Technical change to: socket wrench set SK WSD-S 1,5-10,0

- PCN-PW63xxxx-20260415-00-A DE
- 15.04.2026

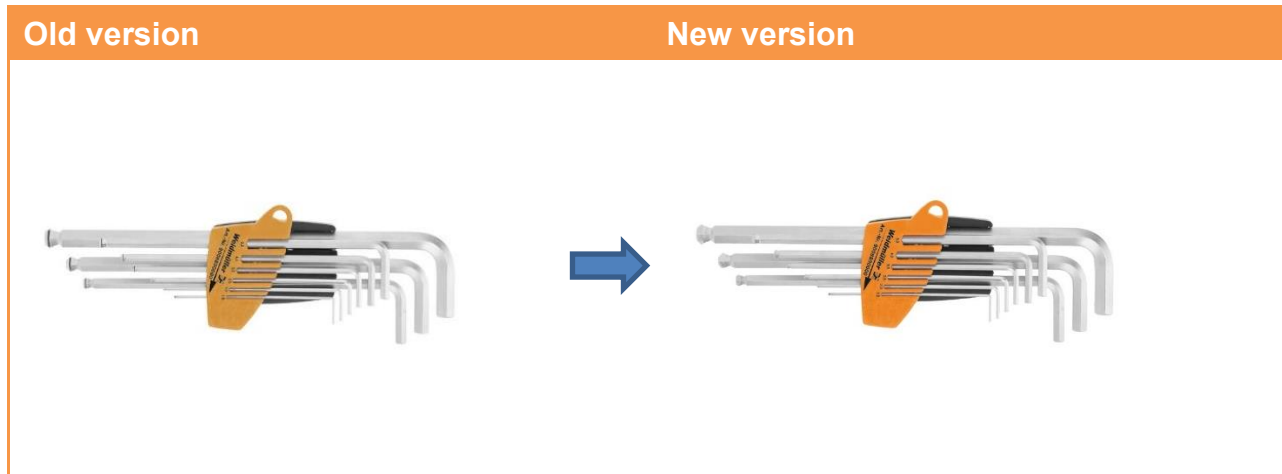
The SK WSD-S 1.5-10.0 wrench set currently includes the MagicRing®. The MagicRing® is a holding feature that secures screws using a spring ring without a magnet.

Currently, the pin keys are chrome-plated.

The MagicRing® will be discontinued. The surface will be a validated galvanized surface with even better corrosion protection.

This feature MagicRing® was hardly used and relatively unknown. But it was very expensive.

The surface finish is being changed because Chromium VI is likely to be banned on surfaces and because the new surface offers better corrosion protection.
